Addendum 02

Date: December 19, 2017

To: Bidding General Contractors and Subcontractors
From: Ben Walter, CWS Architects
Regarding: St. Francis Apartments Phase 2 – Waterville, Maine
Subject: Addendum 02

THIRD FLOOR
FRAMING PLAN
REF: DWG S1.2

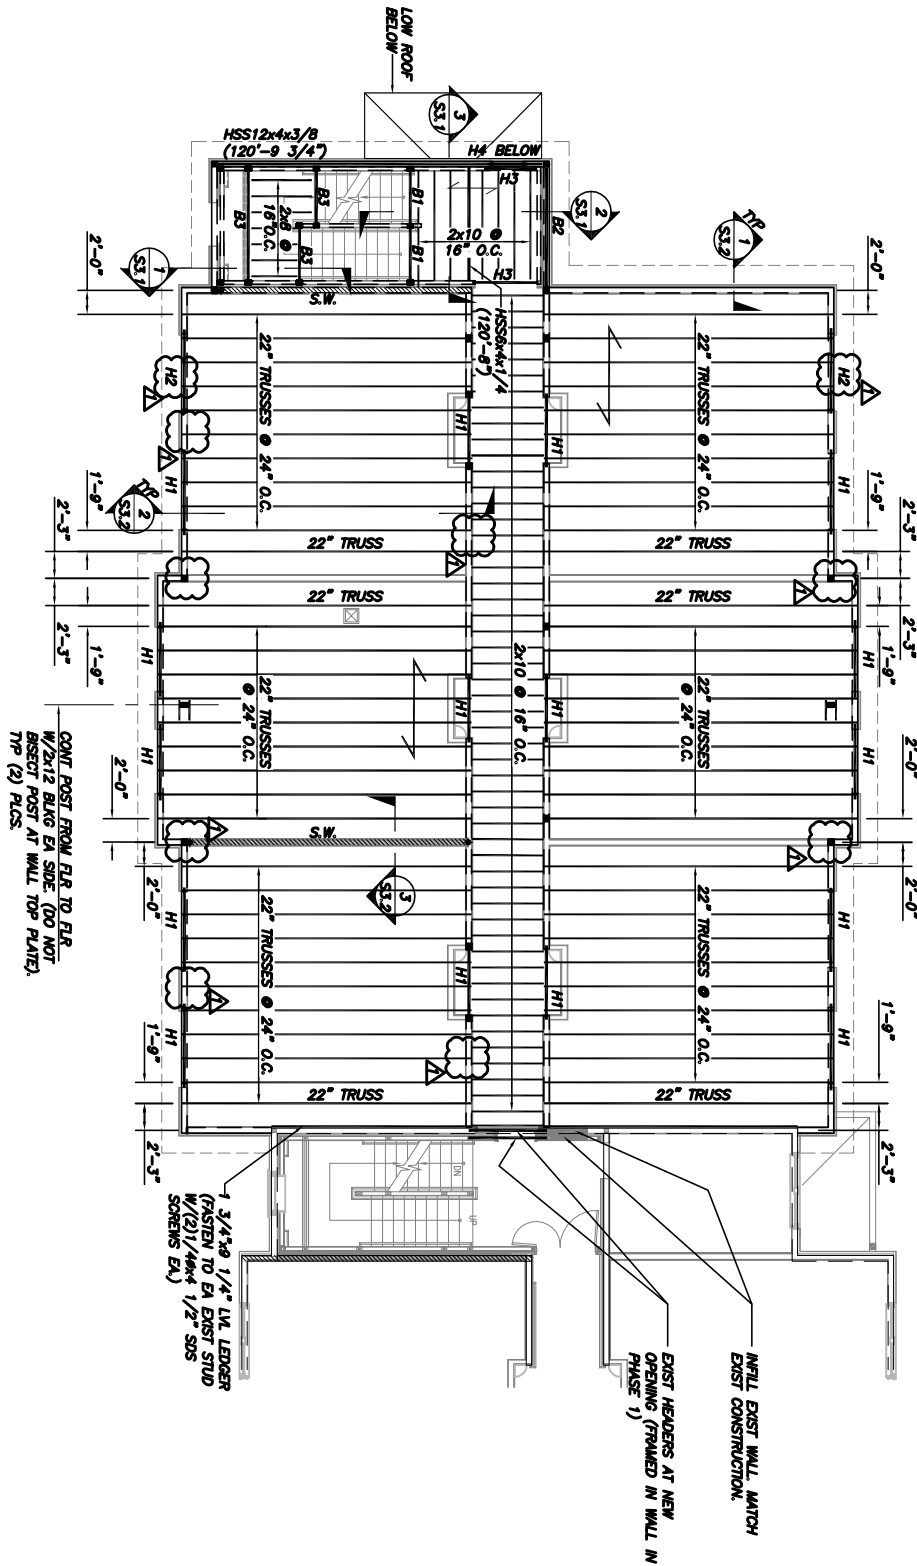
4. **Question:** S1.2 third floor and roof plans show columns which are not identified. Are they to be the same as those shown on the foundation plan? They are not shown at the lower level framing plans.
Response: Yes the columns are the same as shown on the foundation plan and extend, at the same size, up through all floors to the roof (see SKS01 to SKS04 for clarification).
5. **Question:** S3.3 Shearwall Schedule shows all hold-downs to be HDU8. Shearwall elevation to the left of the schedule shows HDU8 at first, HDU5 at second, and HDU2 at third floors. Which is correct?
Response: The notations on the shearwall elevation indicates the hold down at the elevated floors. The holddown in the shearwall schedule is at the base of the wall (per note 3).

6. **Question:** S1.2 Roof – are the posts at each end of the B4 beam spanning bump-outs intended to be continuous to the foundation?

Response: Yes, the posts are intended to be continuous to the foundation (see SKS01 to SKS04 for clarification)

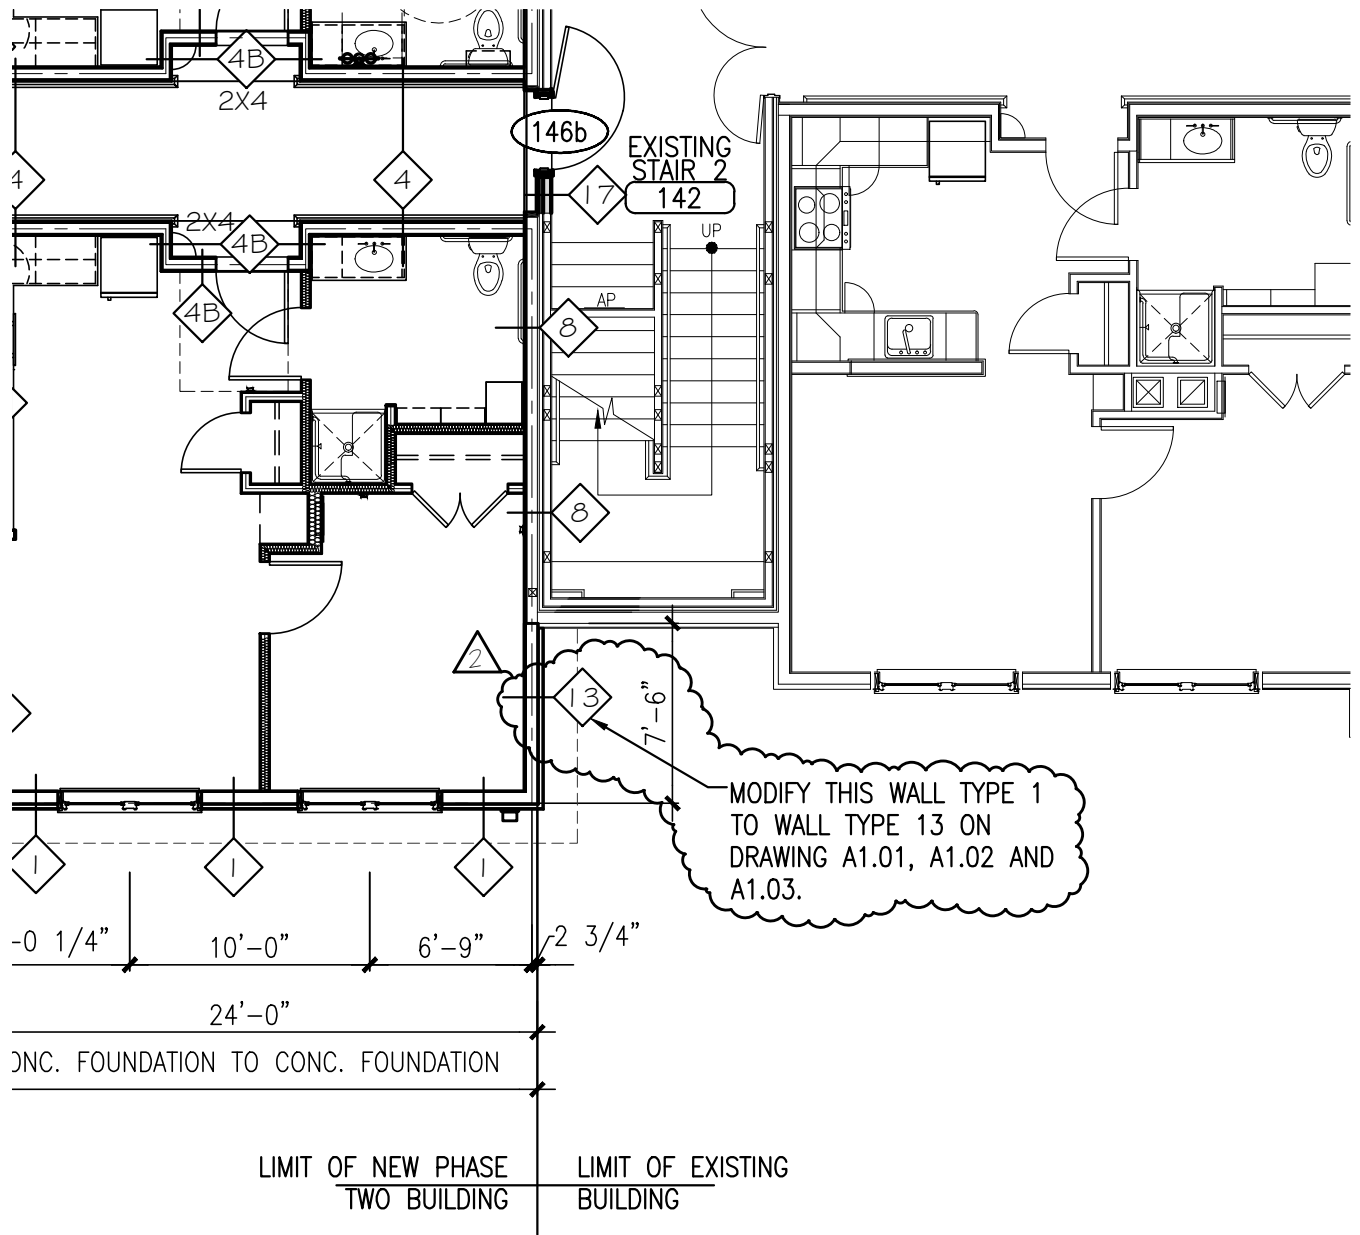
8. Change the tag of 'Wall Type 1' to 'Wall Type 13' at the location indicated on SKA-03 from foundation to eave, i.e. first, second and third floors plans A1.01, A1.02 and A1.03.
